Response to Submissions

Blackwattle Bay State Significant Precinct

July 2022

Figure 4 – Revised Precinct Plan

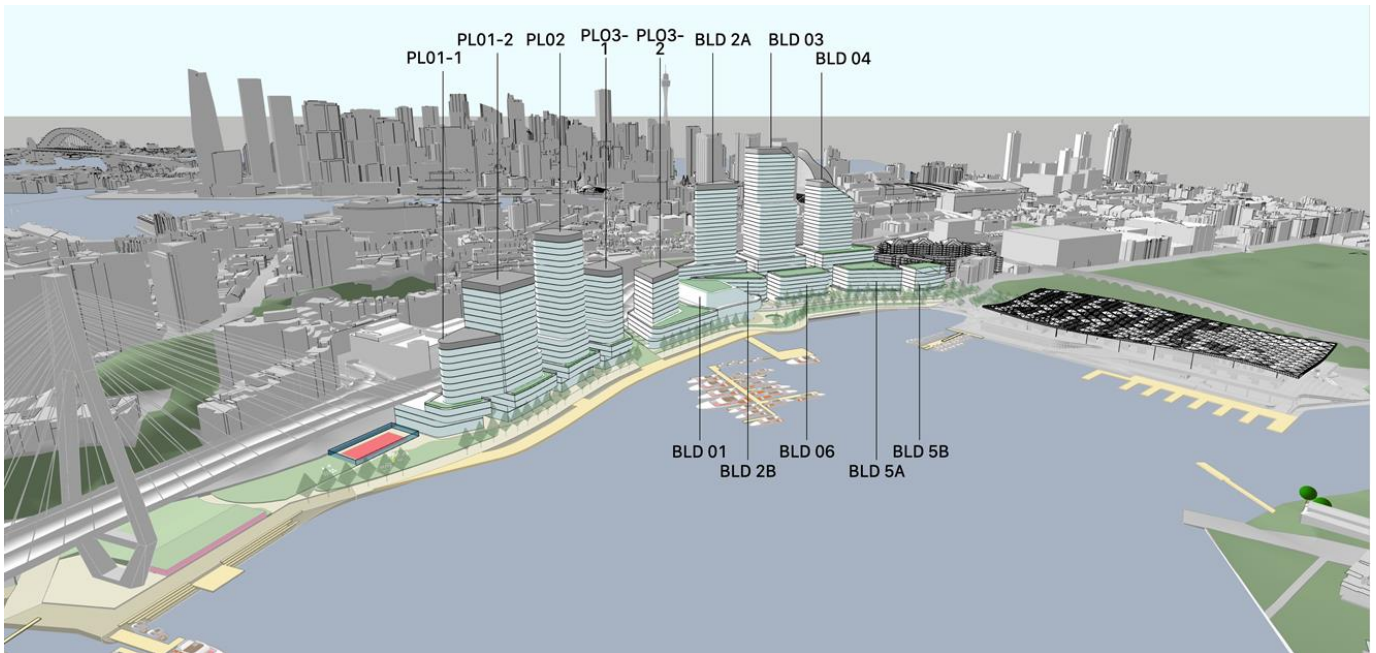
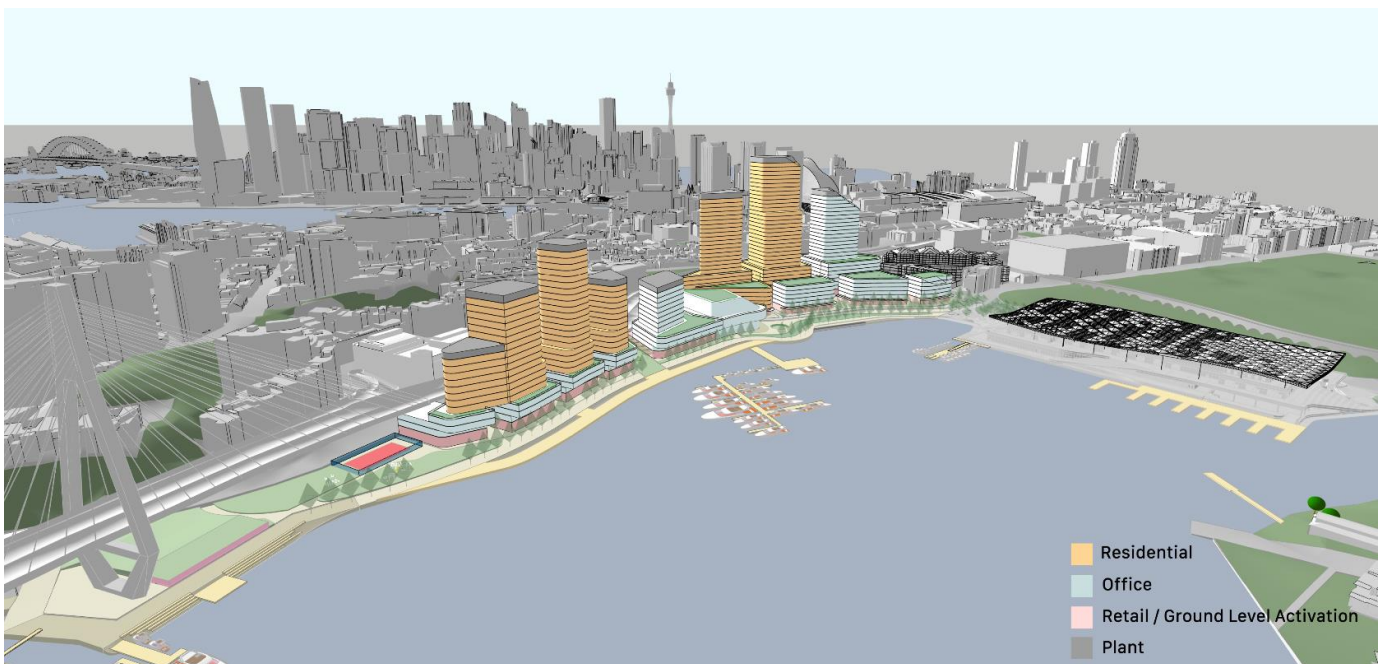
- *Investigate alternate built form options and undertake testing of alternate site configurations, in particular for the narrower northern end of the precinct to provide a better foreshore promenade experience. This should include master planning of one or more of the privately owned sites based on different lot configuration of one or more allotments, requiring amalgamation of sites to provide more lot configurations that better respond to the constraints of this part of the precinct. This should also include an improved transition to the waterfront including the use of podiums and increased setbacks from the water edge.*

- Adopt design refinements or provide further justification for the siting and design of residential components of the proposed rezoning to address amenity concerns, especially in the northern end of the precinct where development abuts the Western Distributor. This could include non-residential land uses and a minimum setback of 3m from the western distributor at podium and 6m at tower levels.*

The building height and massing has been adjusted in the Revised Precinct Plan, resulting in both reduced building heights and gross floor area across the precinct. Buildings on the existing Sydney Fish Market site have been reduced, including the tallest by 15m, as well as adjustments on the private landowner sites to achieve improved amenity outcomes.

Finally, in response to the submissions received, the design team investigated lower heights across the precinct. Instead of a uniform reduction in heights, the design team sculpted the built form to create a dynamic mid-scale skyline which reinforced the above-mentioned amenity improvements. The heights have generally been lowered across the precinct and gross floor areas have been reduced by 15% on average.

- increased tower separations for wind paths
- stepped building envelopes towards waters edge
- reduced footprint and revised location for Building 2A
- reduced tower heights, and
- location of awnings on buildings.

Figure 7 – Study Point locations for seasonal analysis – Assessed Points in Green (source: Windtech Wind Comfort Seasonal Analysis)

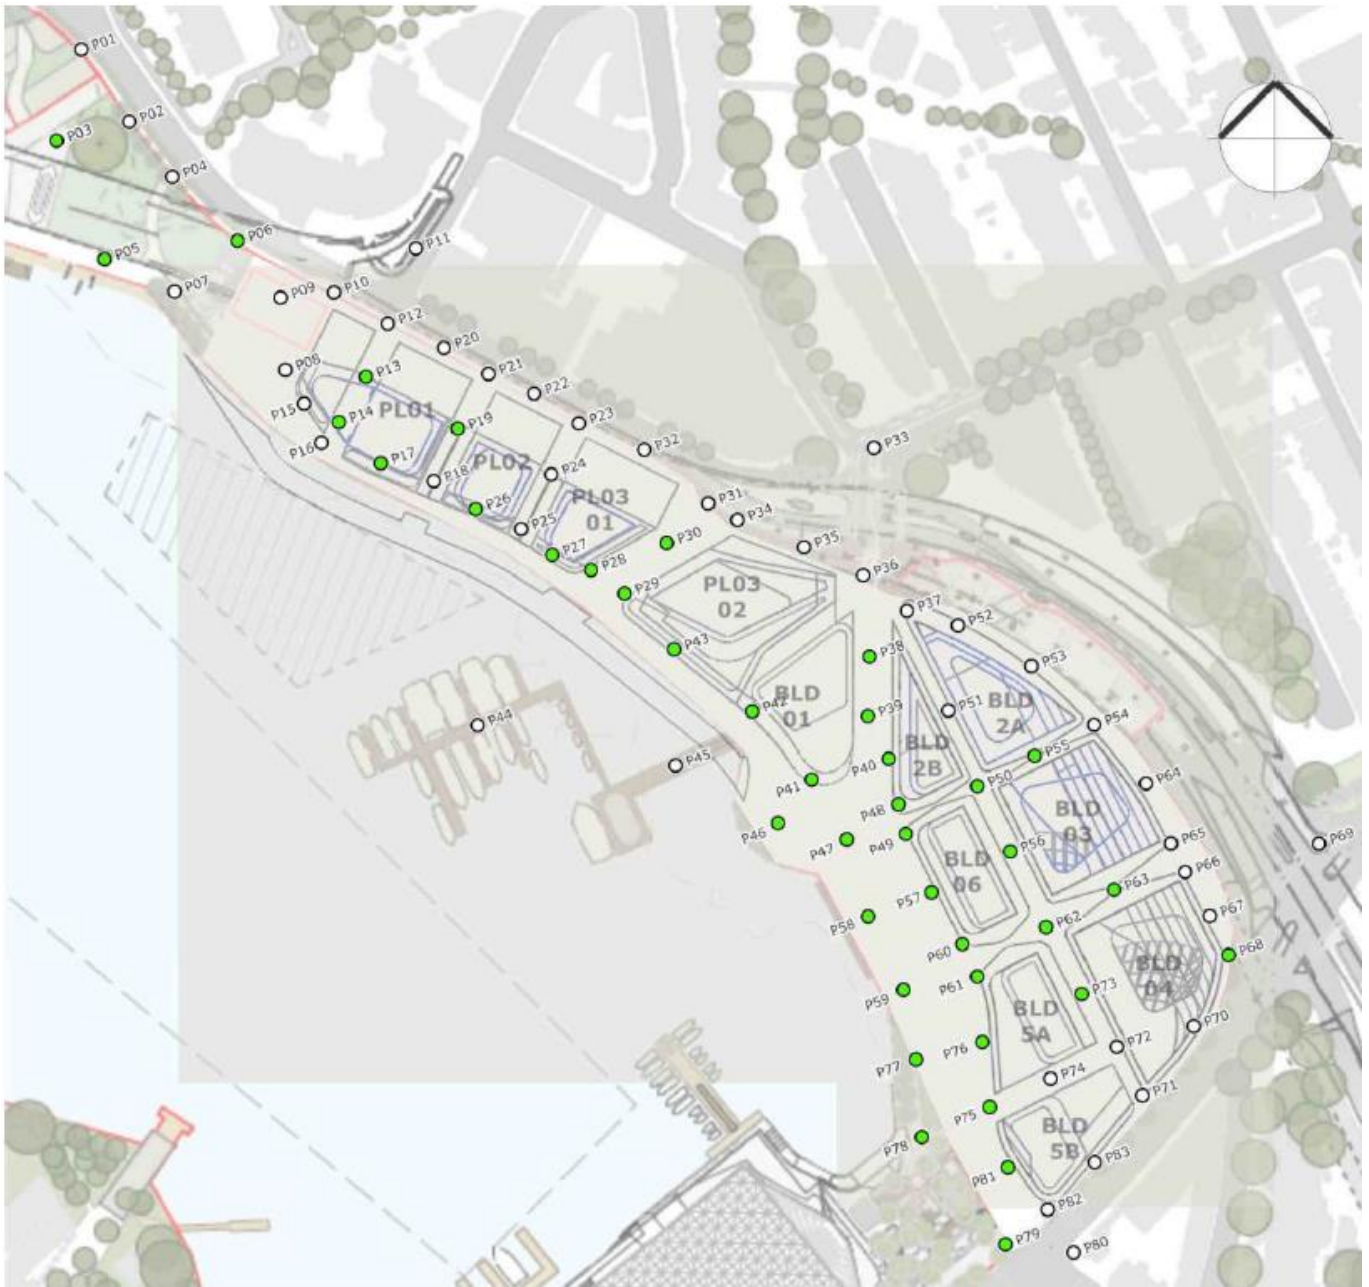
- *The wind assessment is to be revised to ensure application of appropriate criteria and achievement of appropriate wind conditions based on expected use of areas of public domain, e.g. sitting, standing, walking. This needs to include identifying areas appropriate for sitting within new open spaces and*

Windtech have undertaken an assessment of the Revised Precinct Plan in a new Pedestrian Wind Environment Study provided at **Attachment 7**. This assesses the safety and walking comfort criteria. A further Wind Comfort Seasonal Analysis has been undertaken (**Attachment 8**) with each of the 40 study points assessed against the comfort criteria listed in Table 3 below. The results demonstrate that the precinct has the ability to achieve suitable wind conditions, particularly considering the nature of the location as an exposed waterfront destination.

The Wind Comfort Seasonal Analysis looked at the 40 study points highlighted in green in Figure 7 below. The comfort level is calculated for each month in 3 hourly intervals looking at five criteria as shown in Table 3 below. This includes sitting, standing and walking criteria.

In the exhibited Precinct Plan there were several points where the wind safety criteria was exceeded. The Revised Precinct Plan has only one point that exceeded the safety criteria, Point 61. Windtech recommend that it can be mitigated with localised screening.
